ADDENDUM NO. 2

This Addendum contains changes to the requirements of the Bidding Documents, Technical Specifications and Construction Drawings, which have been issued to date. Such changes are to be incorporated into the Construction Documents and shall apply to the Work with the same meaning and force as if they had been included in the original documents. Wherever this Addendum modifies a portion of a paragraph of the Project Manual, or portion of any Drawings, the remainder of the paragraph or Drawing shall remain in force;

Upgrade AHU & Ventilation System
LoGrasso Hall
261 Temple St., Fredonia NY 14063
SUNY Fredonia Project No. 051039

DRAWING NO. HM100
Drawn By: SPF
Checked By: RJH
Project Mgr: SPF
Project No: 211263.00

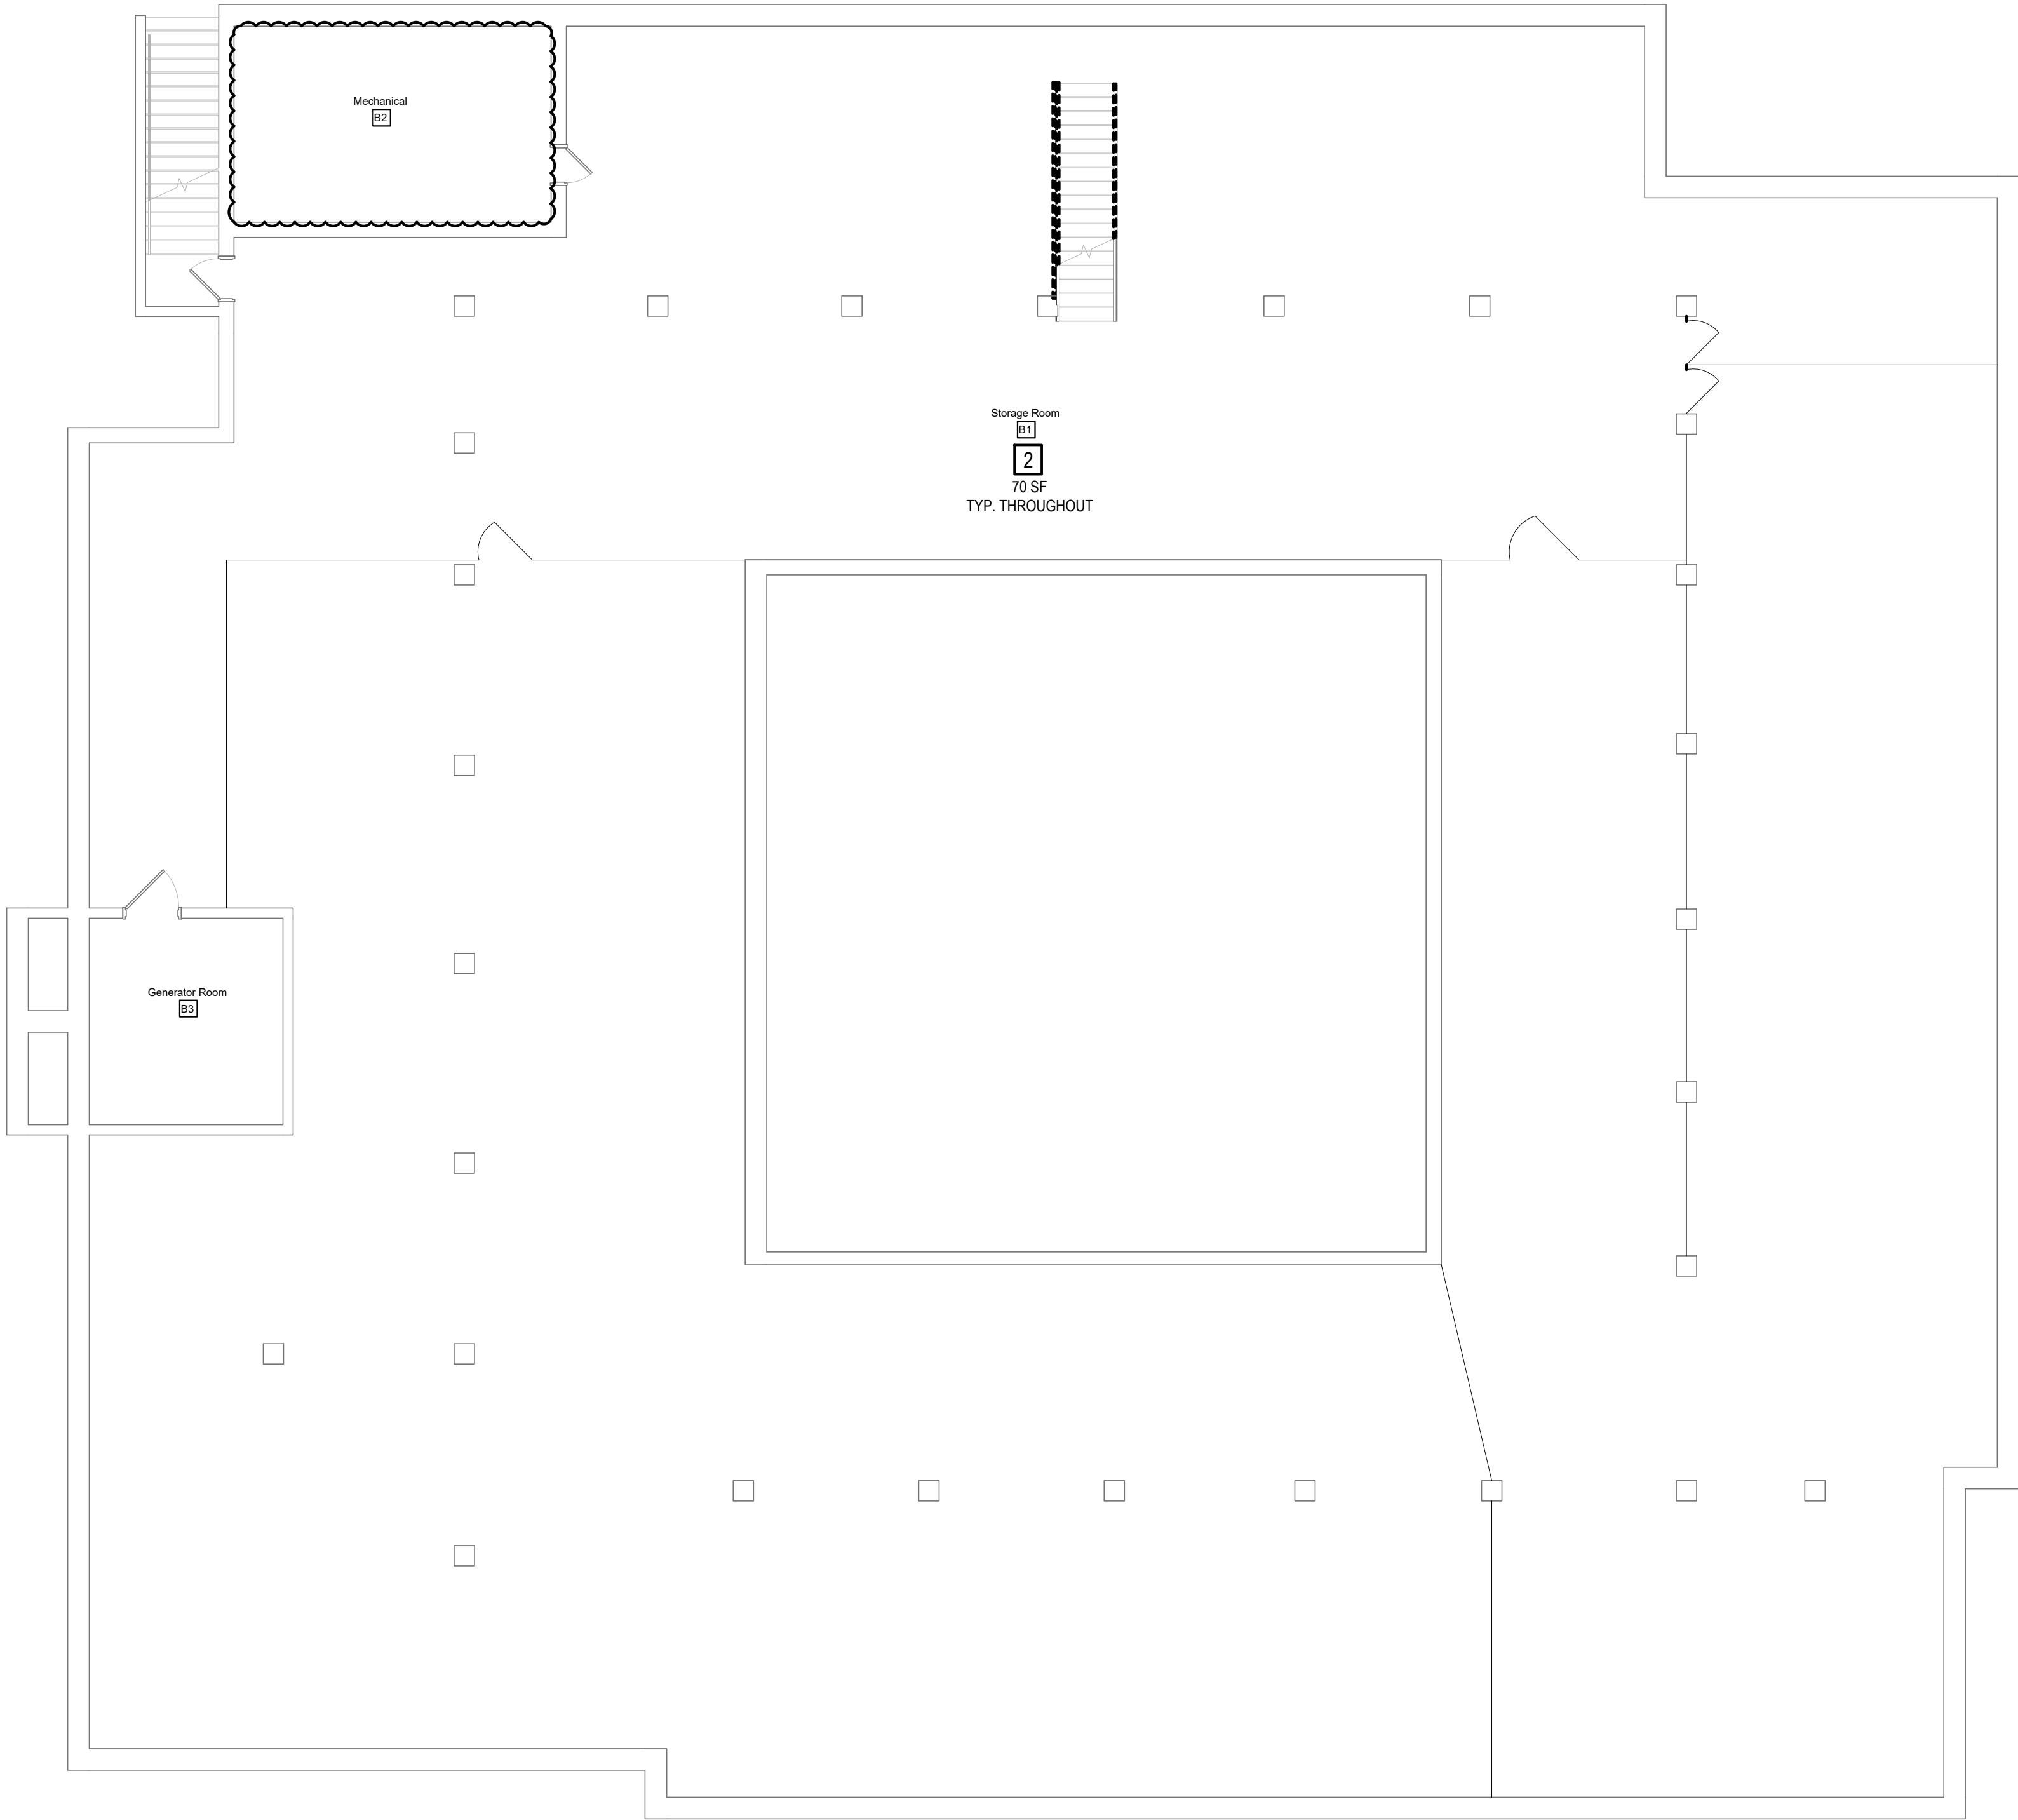
6. Drawing HM-100

- a. REMOVE Keyed Asbestos Removal Note 2 from Room B2 – Mechanical Room

DRAWING NO. **HM101**

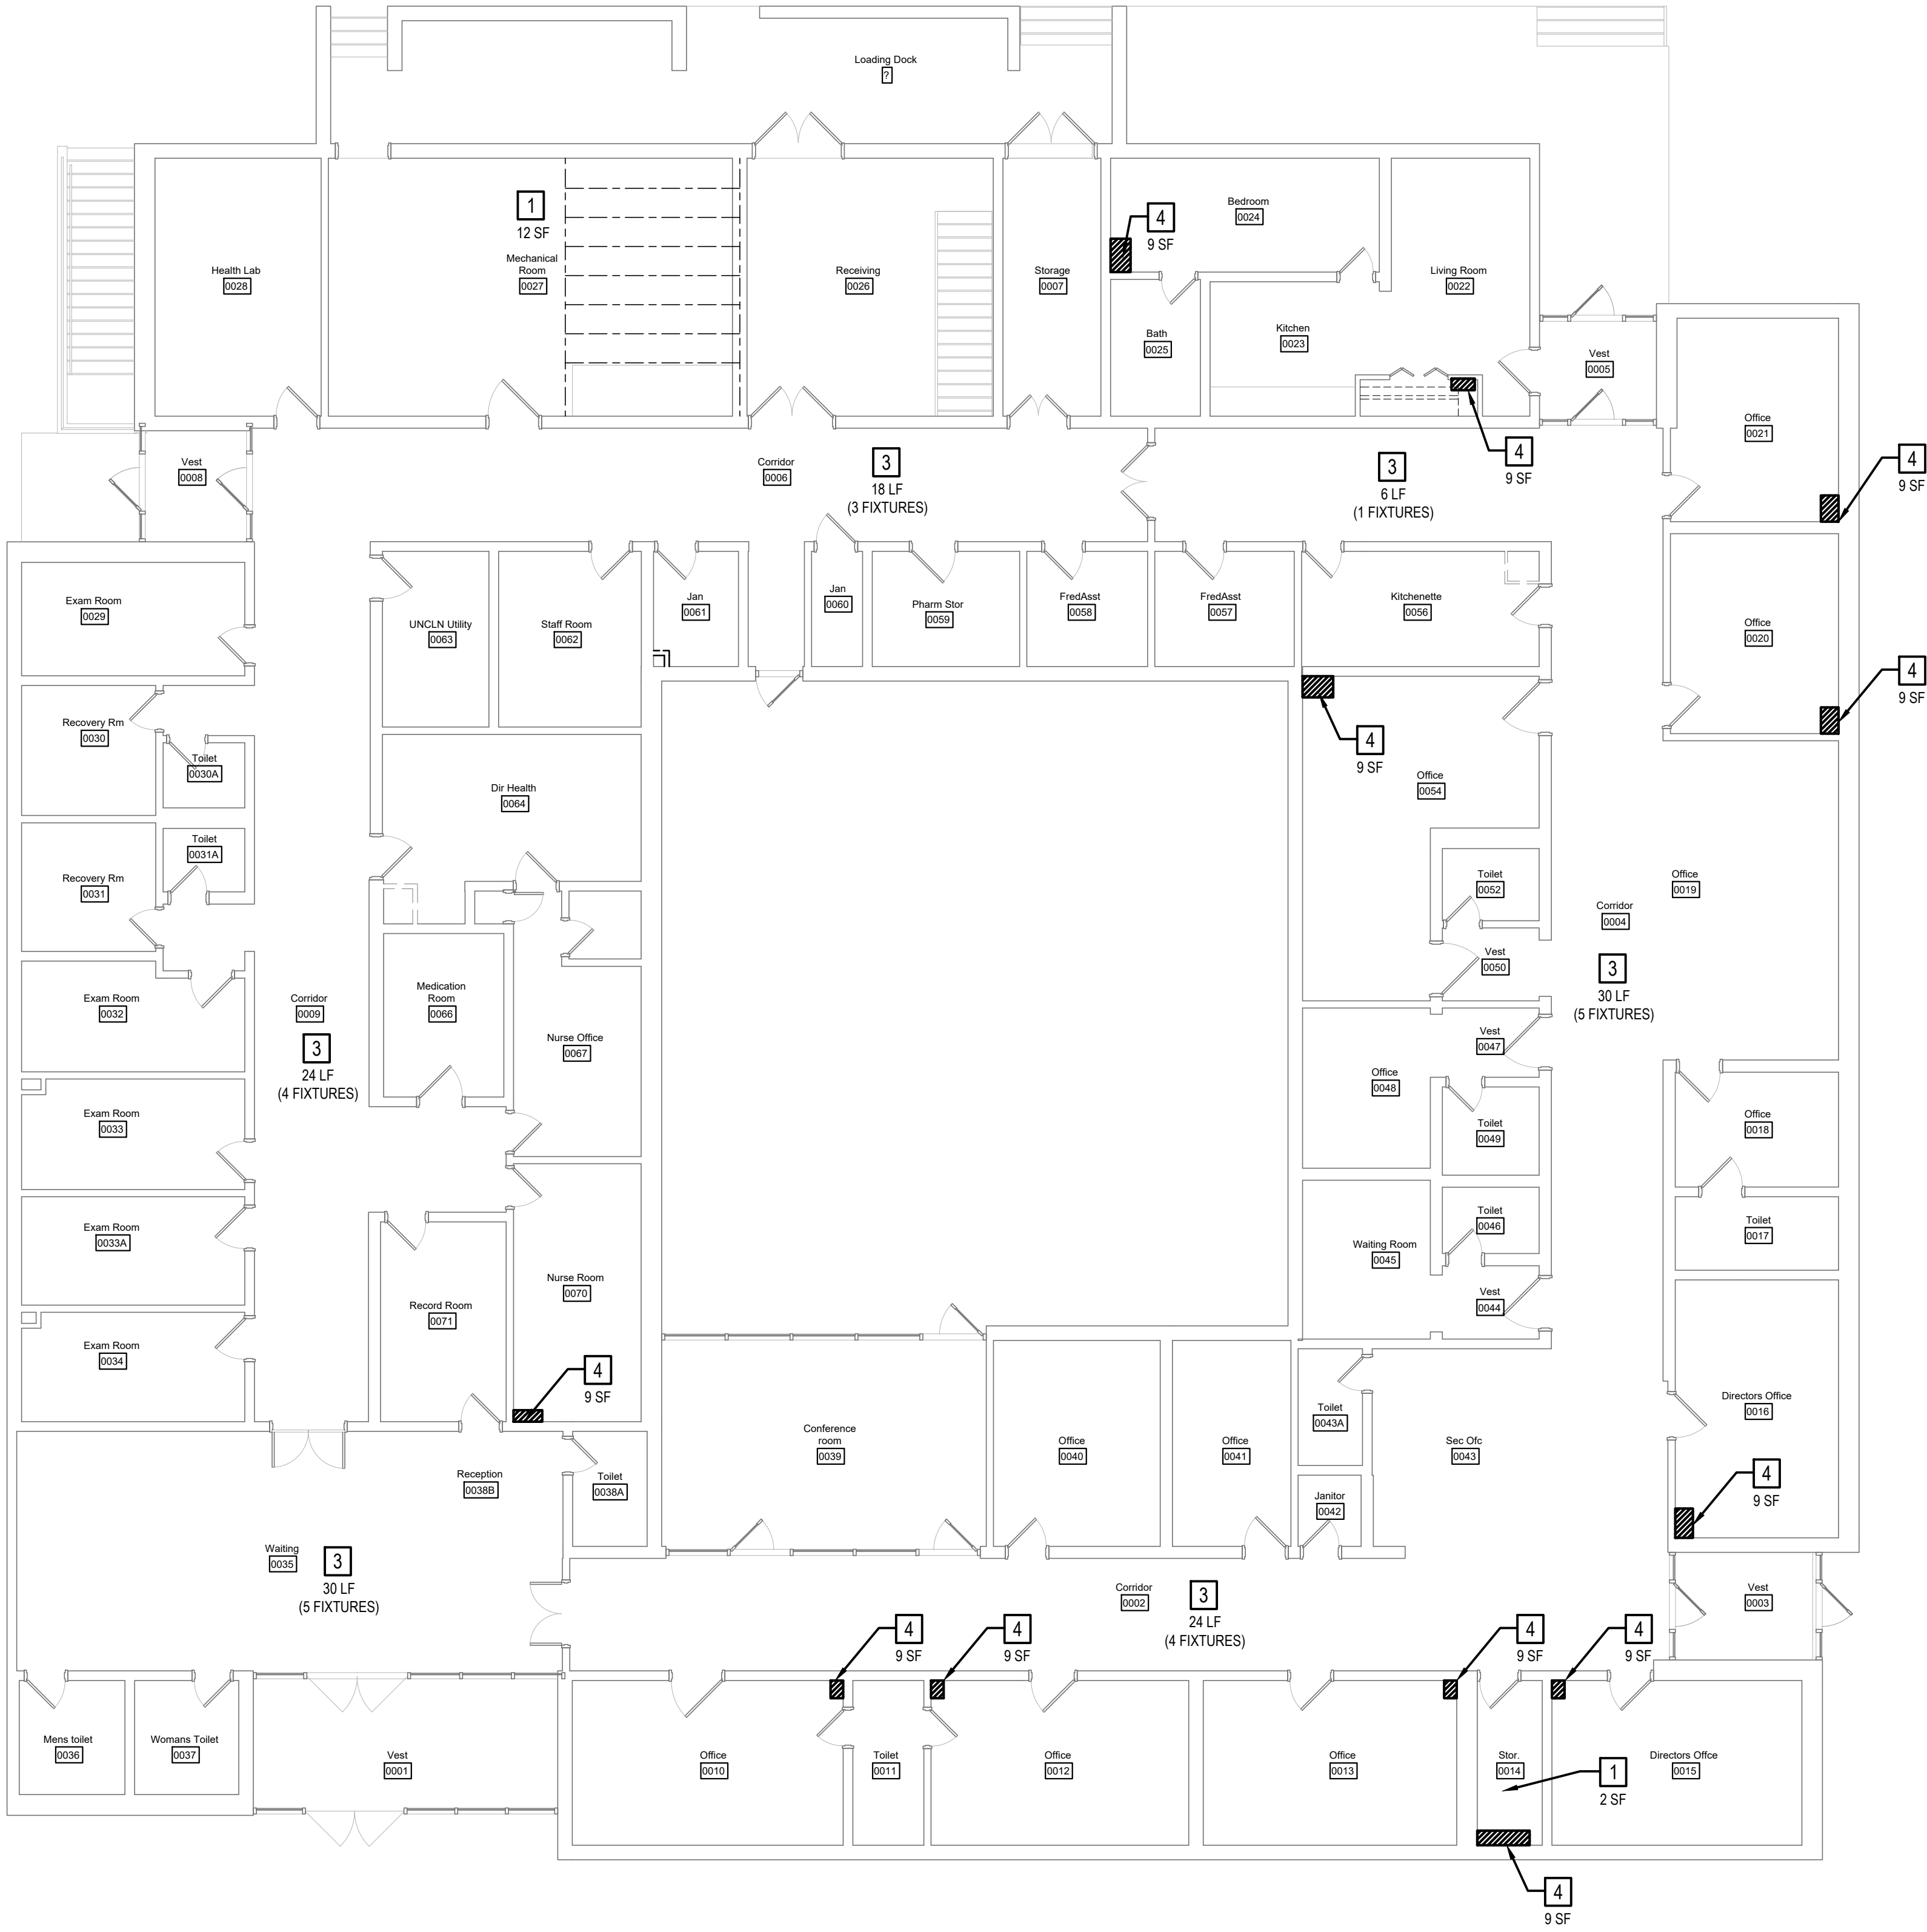
4. Drawing HM-100 & HM-101

- a. REVISE Keyed Asbestos Removal Note 3 to:

- 1) "3. REMOVE AND PROPERLY DISPOSE OF ASSUMED ASBESTOS-

CONTAINING RECESSED LIGHT FIXTURE CLOTH WHIP WIRE
INSULATION BACK TO NEAREST JUNCTION BOX. REMOVAL IS
CONSIDERED OSHA CLASS II WORK. ALL WASTE GENERATED
SHALL BE CONSIDERED EPA CATEGORY II NON-FRIABLE."

SK-A1

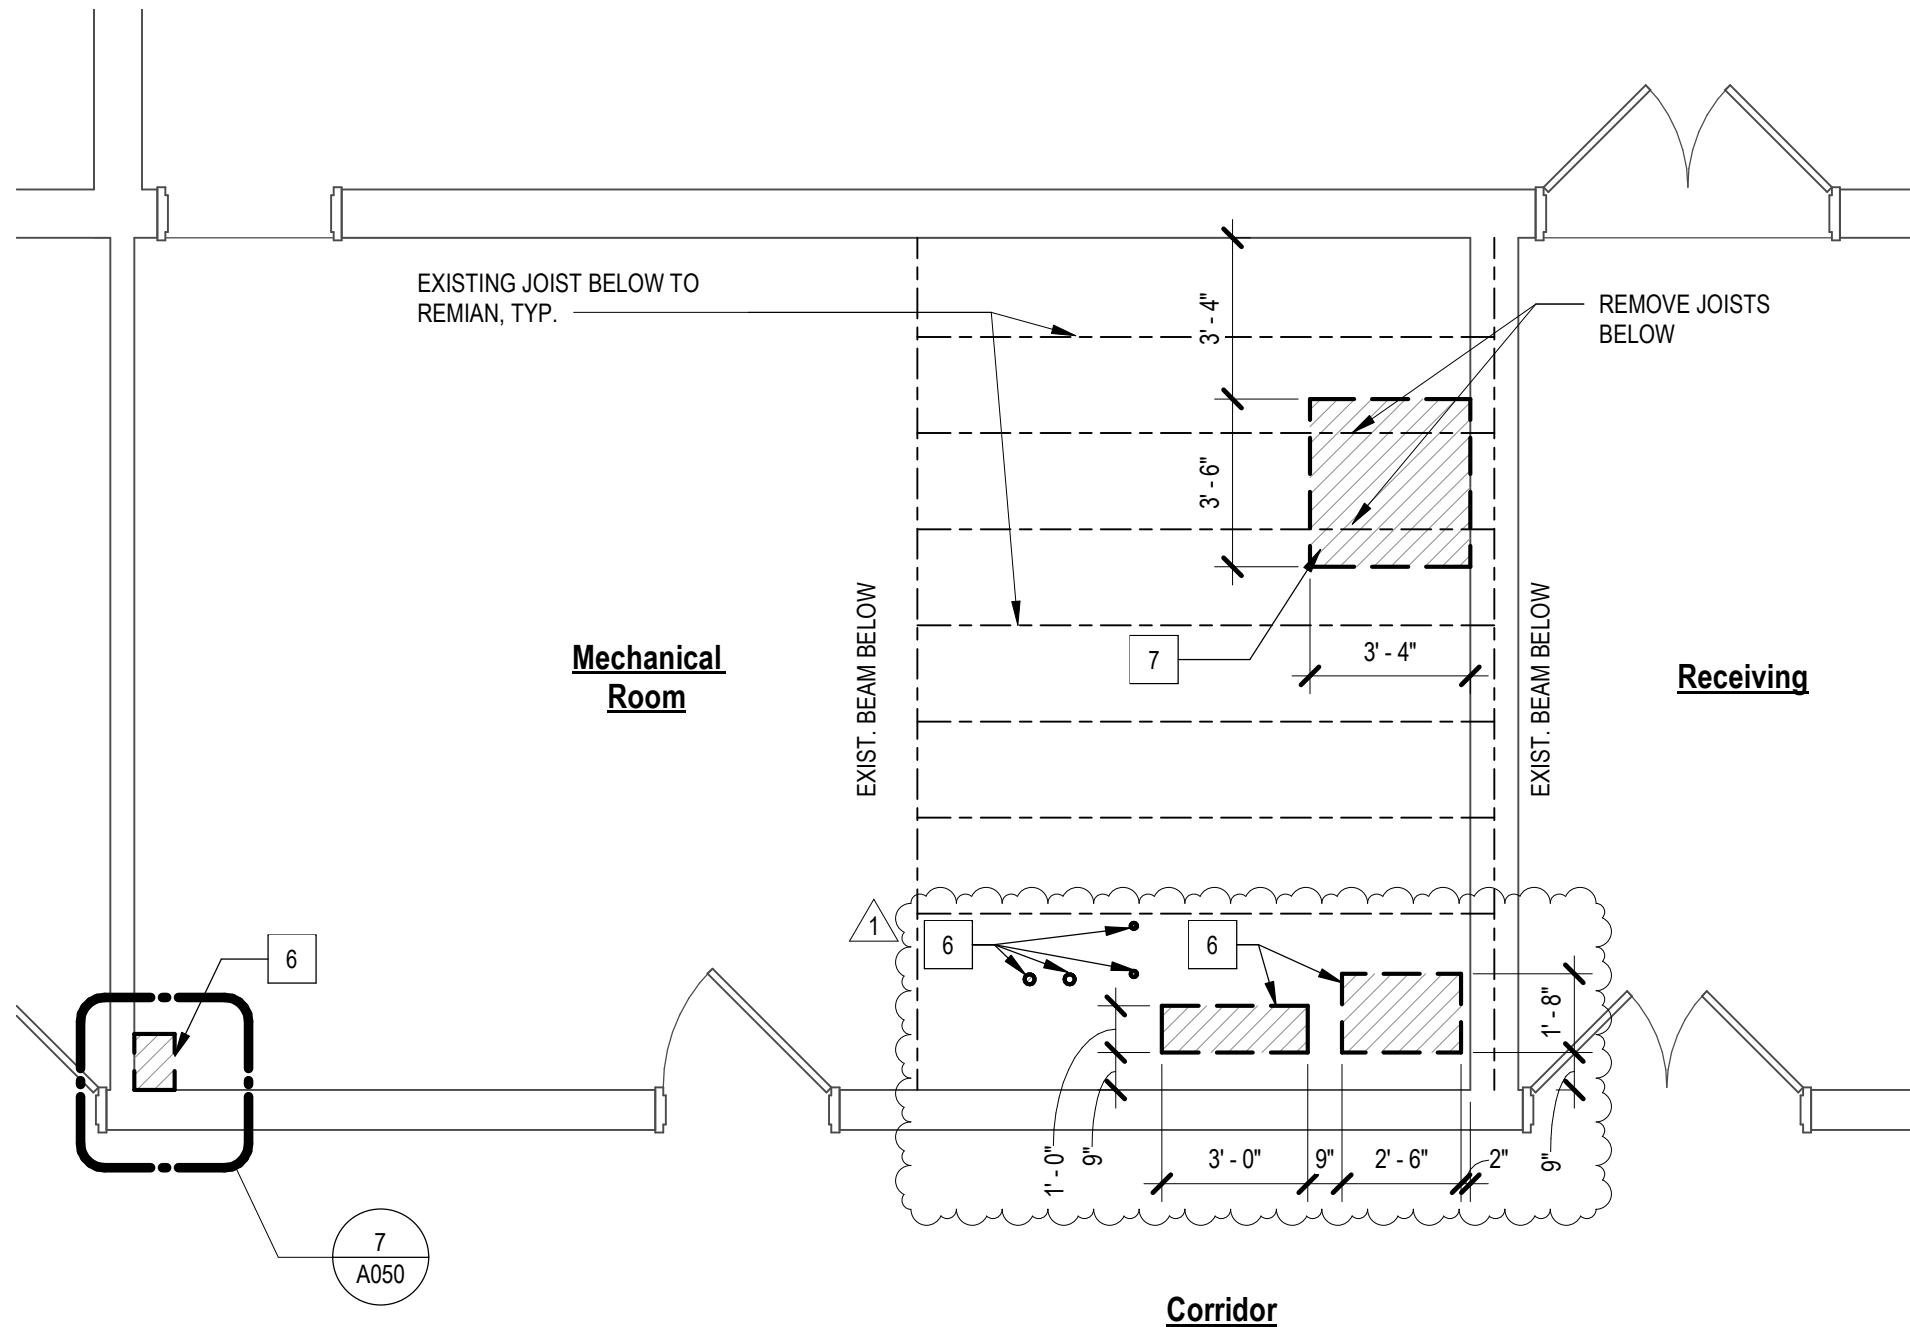
1. Drawing AD100 – FIRST FLOOR DEMOLITION

- a. REVISE Plan 1 to capture enlargement of existing mechanical openings to accommodate new work.

1
SK-A2

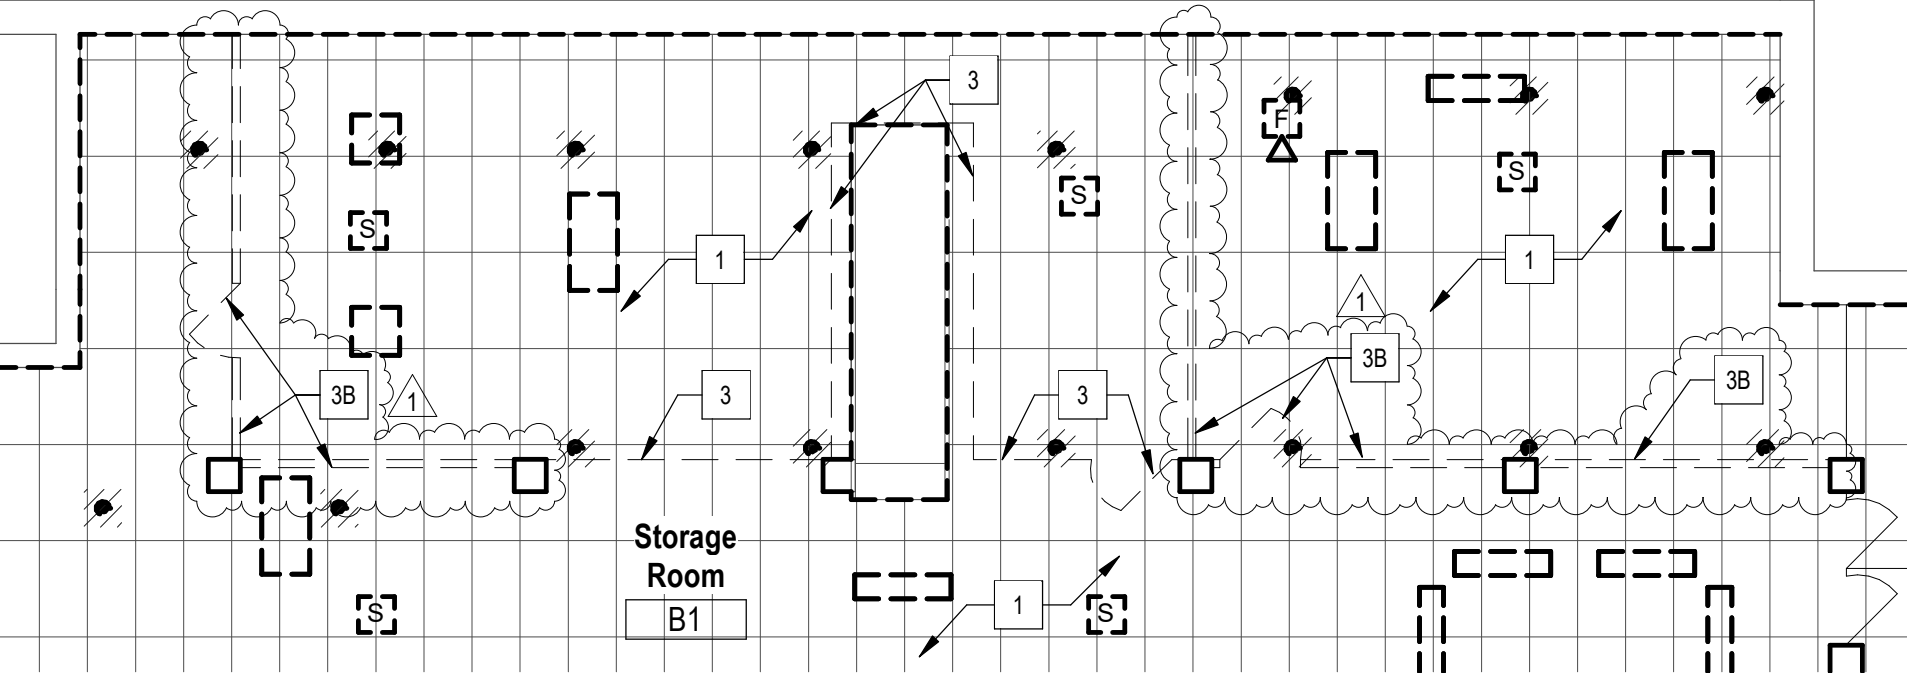
2. Drawing AD111 – CEILING DEMOLITION PLANS.

- a. REVISE Plan 1 and associated keynotes and legend as depicted on SK-A1.
